**North Little Rock Planning Commission**  
**November 18, 2025 - Agenda / Public Hearing 4:00 PM**  
**City Council Chambers – 300 Main Street, NLR, AR 72114**

**Planning Commission Hearing Items:**

Drawing Name: \_\_\_\_\_  
 Date: 09/20/25  
 Type: V9.0  
 Project No: 2411  
 Drawn By: \_\_\_\_\_  
 Scale: As Noted  
 Drawing No: C2

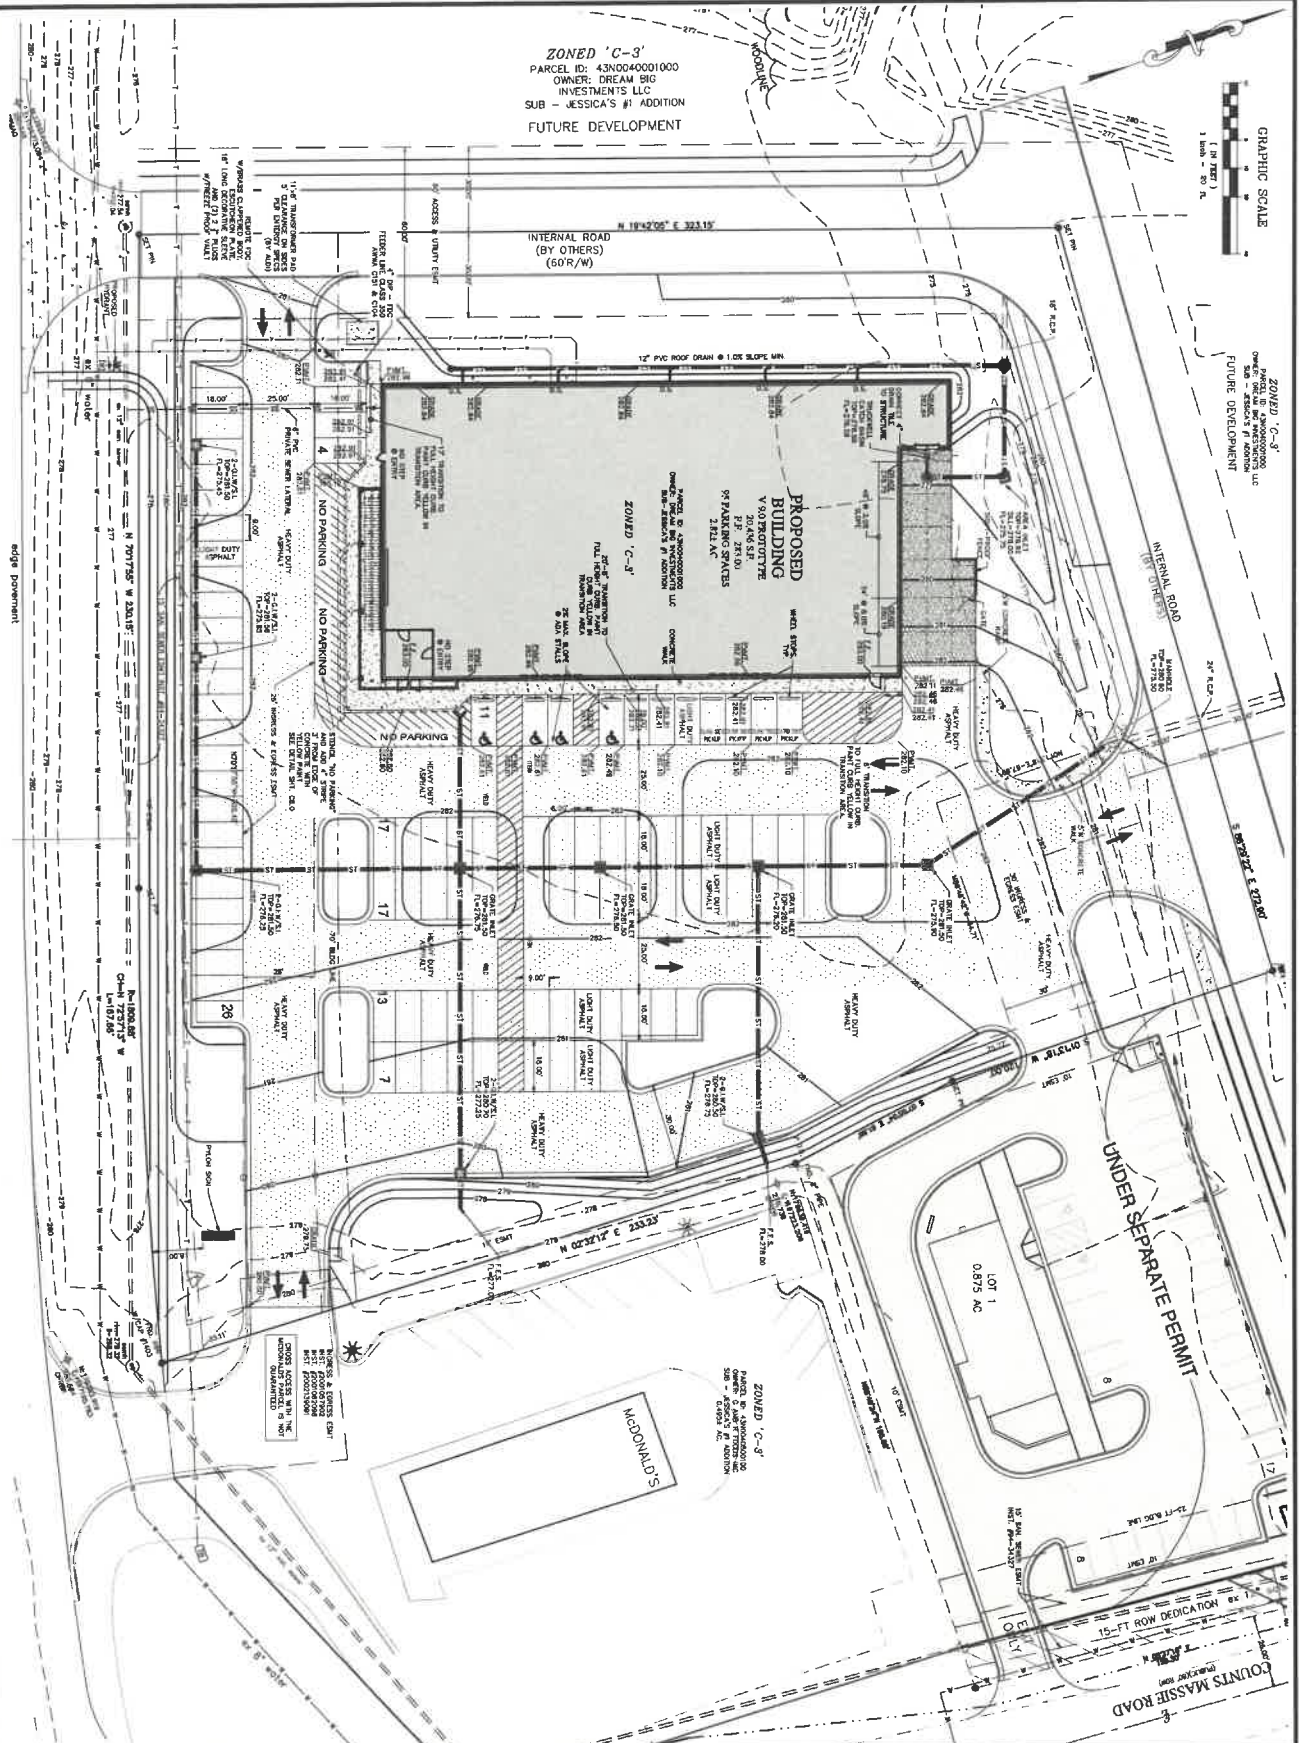
12. Meet the requirements of NLR Wastewater, including:
- a. White Oak Connection fee applies. Payment of this fee is required prior to connection to NLRW's collection system.

- b. Contact North Little Rock Wastewater for the location of the existing

- connection point for development.
- c. Grease interceptor with sampling manhole is required if food will be prepared and served.
  - d. Please submit a full set of plans to [kunderwood@nlrwu.com](mailto:kunderwood@nlrwu.com) for review and approval prior to construction beginning.

**SD2025-55 Cooper Square Addition Lot 1RR SPR for an 8-bay auto repair shop @ 11601 Maumelle Blvd**

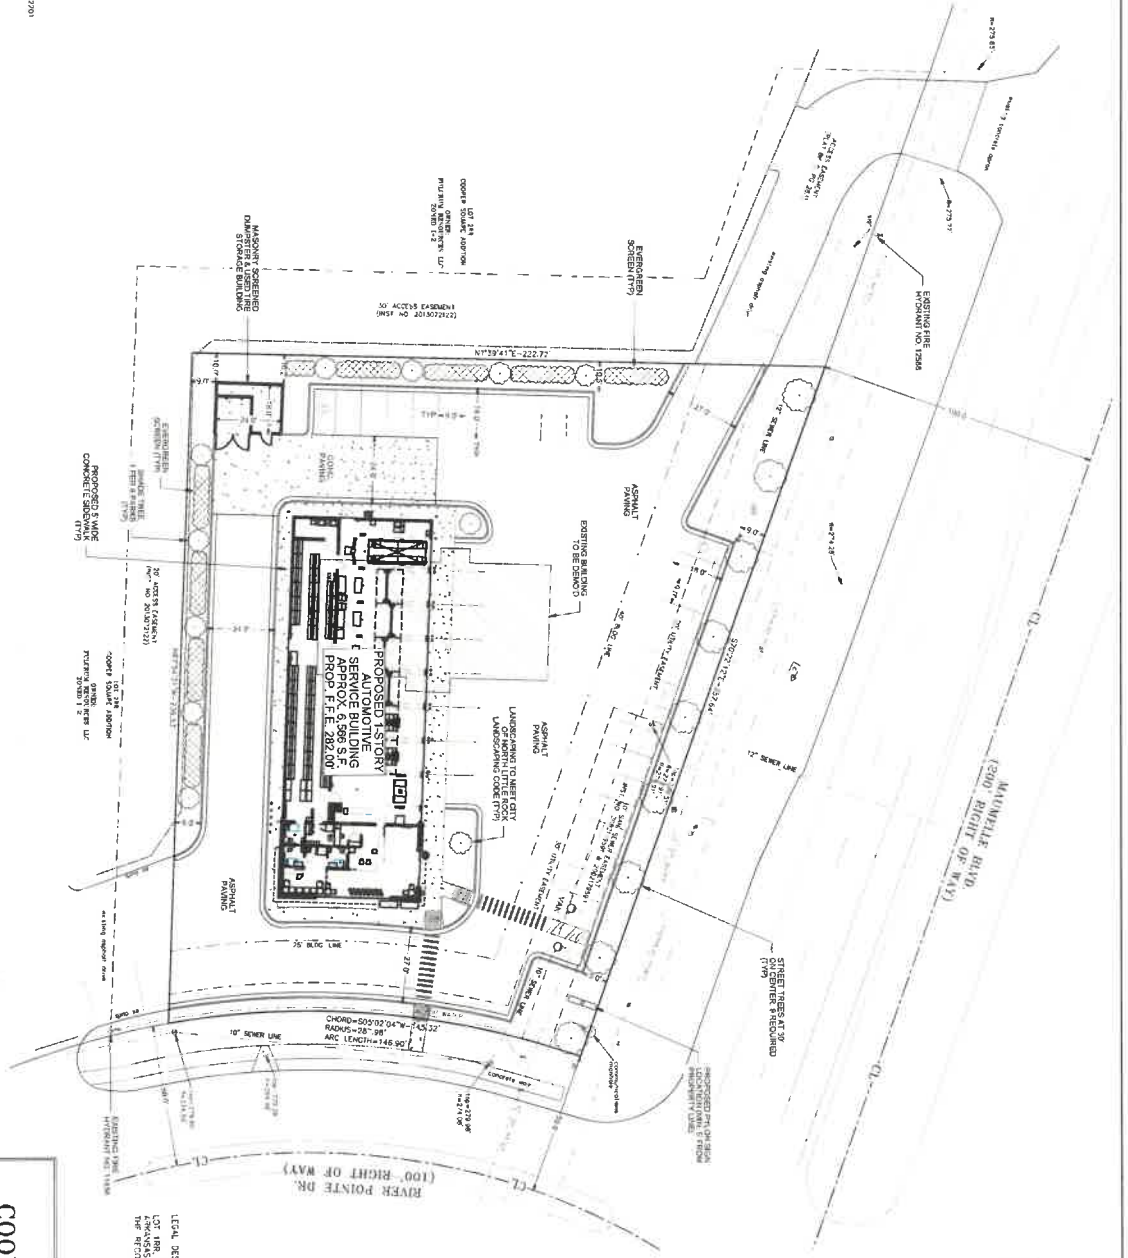
1. Engineering requirements on detention:
  - a. Storm water detention plan not required as there is no increase of or a reduction of impervious surface.

2. Permit requirements/approvals submitted before a building permit will be issued:
  - a. A signed and recorded plat must be on file with the Planning Department.
